TRAFFIC SIGNAL MODIFICATION PLANS OAK STREET (HWY 64) AND FAULKNER PLAZA DRIVE CONWAY, ARKANSAS

TRAFFIC SIGNAL DESIGN
OAK STREET (HWY 64) AND FAULKNER PLAZA DRIVE
CONWAY, ARKANSAS
PROJECT NO.: P2028

TRAFFIC SIGNAL MODIFICATIONS

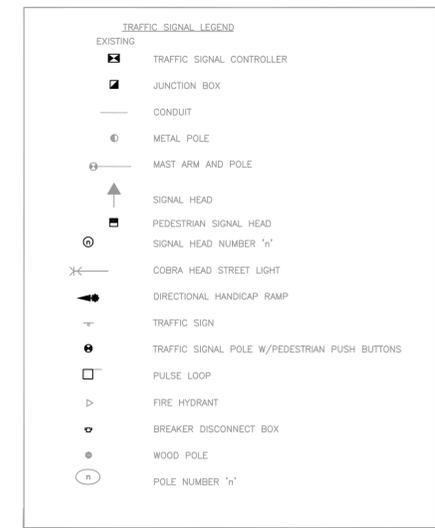
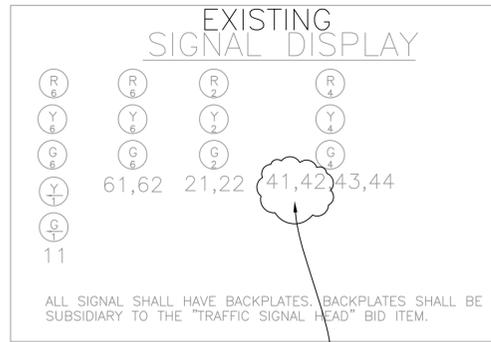
Existing striping does not match proposed lane configuration and vehicle detection; Are these dual left turn lanes now? If so, protected only 3-section signal heads are required per MUTCD and ARDOT standard drawing SD-8. Where are the striping plans?

Is the leading- pedestrian interval just for the WB walk movement during phase 2? Pedestrian phase cannot remain concurrent with phase 4 due to required protected only signal indications and dual left turning vehicles conflict.

ADA improvements to ramp on south side of Hwy. 64 shall be concurrent with traffic signal modification work.
